**BEFORE THE BOARD OF PATENT APPEALS
AND INTERFERENCES**

Application Number: 10/657,343
Filing Date: September 08, 2003
Appellant(s): CHEN ET AL.

EXAMINER'S ANSWER

This is in response to the appeal brief filed 02/04/2008 appealing from the Office action mailed 11/14/2006.

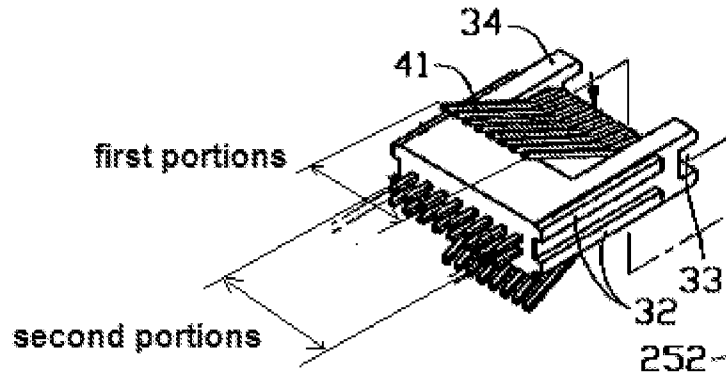
In response to Appellant's argument (on page 8) that "[i]t appears that the spacings between all of the contacts for terminal 42 and terminal 61 are identical",

please see the following figure, which shows that the second portions of the contacts being spread along a longer area than the first portion, thus resulting into a greater spacing.
